SUBURBAN HEIGHTS SUBDIVISION, UNIT 2,
RESUBDIVISION OF LOTS 17 AND 18

APPLICATION NUMBER 16 DATE January 15, 2015

DETAIL SITE PLAN

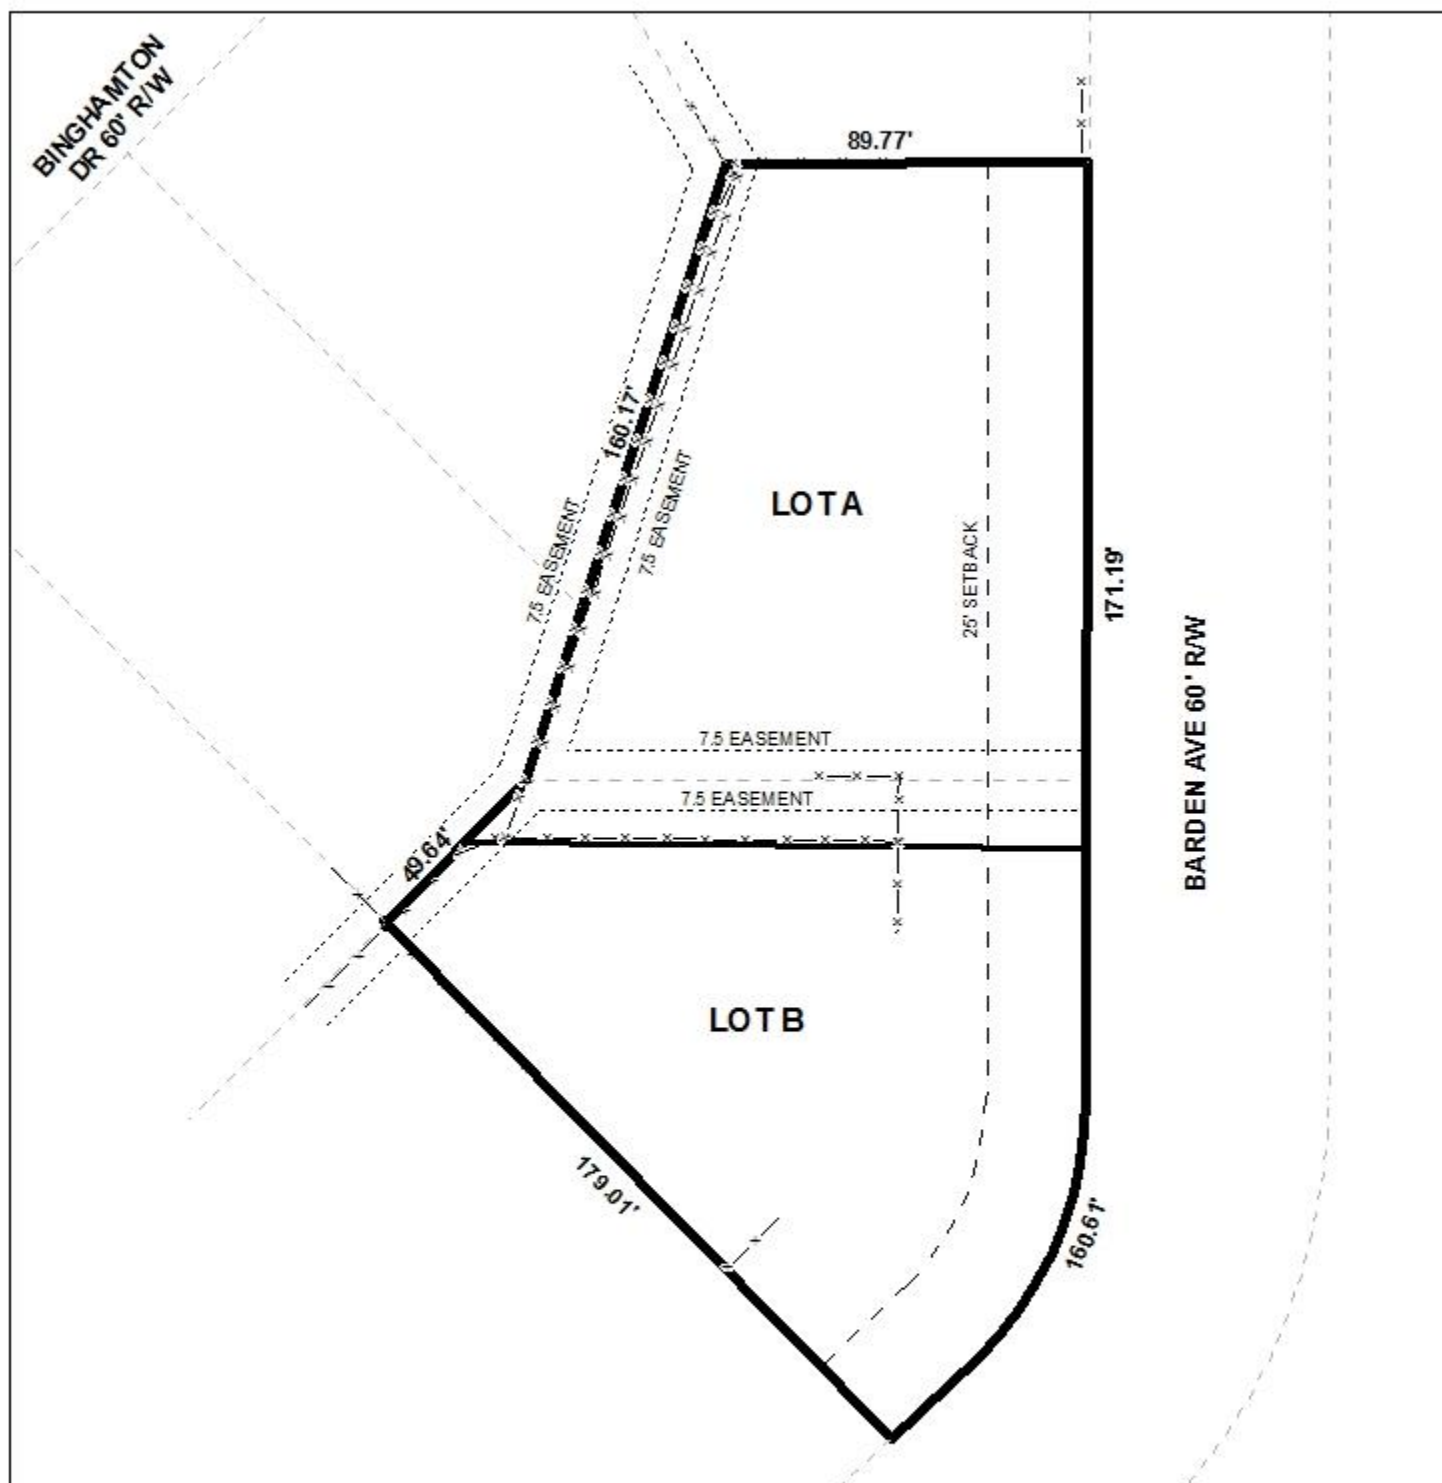
It should be noted, staff can not confirm the presence of public water and sanitary sewer for the proposed lots. The applicant must provide documentation to illustrate compliance for lot size requirements as they relate to Section V.D.2 of the Subdivision Regulations. Proof of public water and sanitary sewer will be required prior to the signing of the Final Plat.

The site fronts Barden Avenue, a minor street without curb and gutter. Barden Avenue is depicted with an adequate 60' right-of-way, thus no dedication is required.

Both Lot A and B are currently developed with a residence, and with one existing curb-cut to Barden Avenue. If approved, a note should be placed on the Final Plat stating each lot is limited to 1 curb-cut with the size, design, and location to be approved by Mobile County Engineering, and conform to AASHTO standards.

The lot sizes are labeled in square feet and acres. If approved, the lot sizes in square feet and acres should be retained on the Final Plat, or the furnishing of a table providing the same information will be required.

The 25' minimum building setback line is depicted on the plat, and should be retained on the Final Plat, if approved.

Both proposed lots have drainage easements on the property. A note should be placed on the Final Plat stating no structures shall be constructed or placed in any easements.

- 1) provision of documentation of public water and sanitary sewer services for the proposed lots prior to the signing of the Final Plat;
- 2) retention of the 25' minimum building setback line on the Final Plat;
- 3) retention of the lot sizes in square feet and acres, or the furnishing of a table on the Final Plat providing the same information;
- 4) placement of a note on the Final Plat stating each lot is limited to 1 curb-cut with the size, design, and location to be approved by Mobile County Engineering, and conform to AASHTO standards;
- 5) placement of a note on the Final Plat stating no structures shall be constructed or placed in any easements;
- 6) placement of a note on the Final Plat stating that any lots which are developed commercially and adjoin residentially developed property must provide a buffer, in compliance with Section V.A.8. of the Subdivision Regulations;
